Virgil C. Summer Nuclear Station (VCSNS) Units 2 and 3
Combined License Nos. NPF-93 and NPF-94
Docket Nos. 52-027 & 52-028

Subject: VCSNS Units 2 & 3 Request for License Amendment and Exemption:
Main Control Room Emergency Habitability System (VES) Design
Changes (LAR 15-03)

Main Control Room Emergency Habitability System (VES) Design Changes

Proposed Changes to Licensing Basis Documents (LAR 15-03)

UFSAR Figure 6.4-2 (Sheet 2 of 2) Simplified Main Control Room Habitability System Piping and Instrumentation Diagram (REF) VES 002

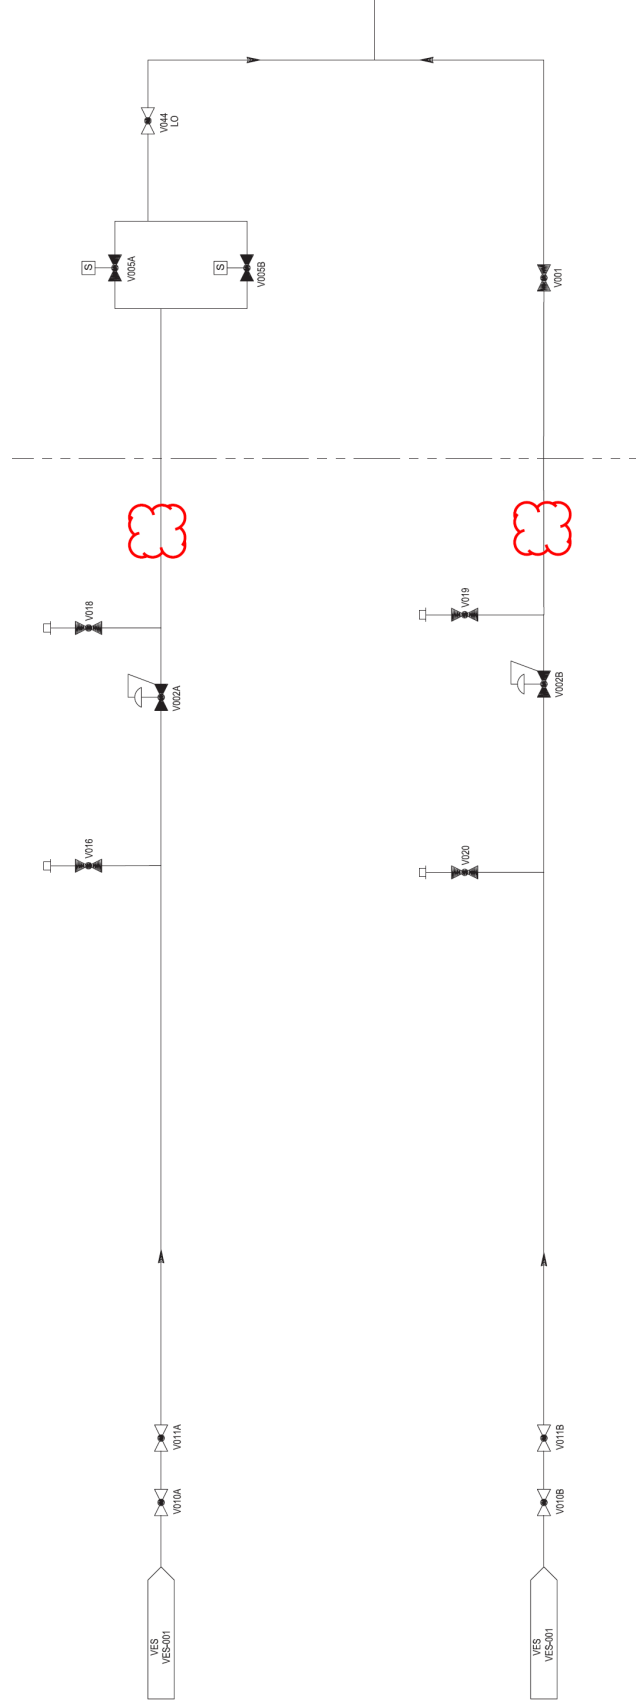
The MCR air filtration line eductor orientation is shown in its system configuration in COL Appendix C Figure 2.2.5-1 and UFSAR Figure 6.4-2 (Sheet 2) reversed from the intended orientation. The proposed change will have the emergency air storage tanks connected to the motive air inlet of the eductor and the MCR air inlet connected to the suction tap of the eductor. The eductor is connected to the discharge of the emergency air supply line from the emergency air storage tanks and to ductwork located inside the MCR envelope that comprises the passive air filtration portion of the VES. The eductor works by directing compressed air from the emergency air storage tanks through a specially designed nozzle to create a powerful vacuum that draws air from the MCR through the surrounding ductwork into the passive air filtration line. The design of the eductor consists of a motive air inlet from the emergency air storage tanks, a suction tap to draw in air from the MCR inner vestibule, and a combined eductor discharge flow directed through the passive air filtration unit.

The current design includes flow control orifices (APP-VES-PY-R01A and APP-VES-PY-R01B) downstream of the pressure regulating valves APP-VES-PY-V002A and APP-VES-PY-V002B. The safety-related design function of the flow control orifices is to provide adequate flow for the VES while maintaining the capability of the air banks to supply breathable air to the occupants of the MCR for at least 72 hours without replenishment. This equipment is shown on COL Appendix C Figure 2.2.5-1 and UFSAR Figure 6.4-2 (Sheet 2). This proposed change would delete the two flow control orifices (APP-VES-PY-R01A and APP-VES-PY-R01B).

3. UFSAR Figure 6.4-2 (Sheet 2) is revised as follows:

a) The orientation of the MCR air filtration line eductor is changed so that the emergency air storage tanks are connected to the motive air inlet of the eductor and the MCR air inlet is connected to the suction tap of the eductor; and

b) Remove the flow control orifices downstream of the pressure regulating valves VES-PL-V002A and VES-PL-V002B.

Revise Figure as shown below:
